Product Change Notification

1. ECN #: 295578

- IPBT - .165 DOUBLE ROW TERMINAL ASSEMBLY

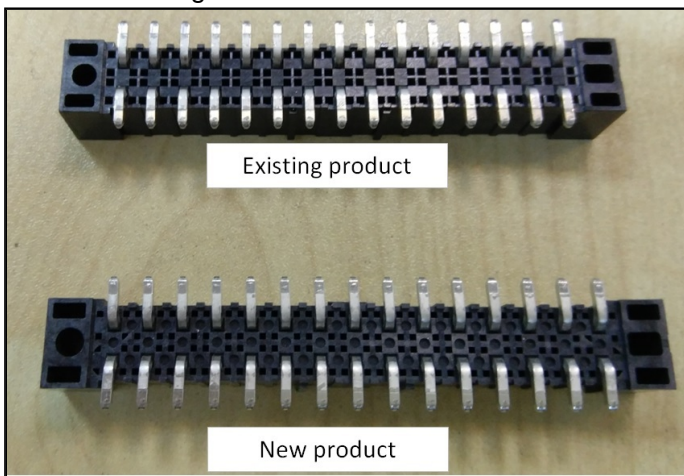
Core out features were added to the bottom side of the body for improved flatness.

Changes can be identified from the bottom side of the connector. The new product has different and additional coring features.

The coring features were added for improved flatness control during the molding process.

- Form - this is a visual change only. There are no performance differences with this product change.
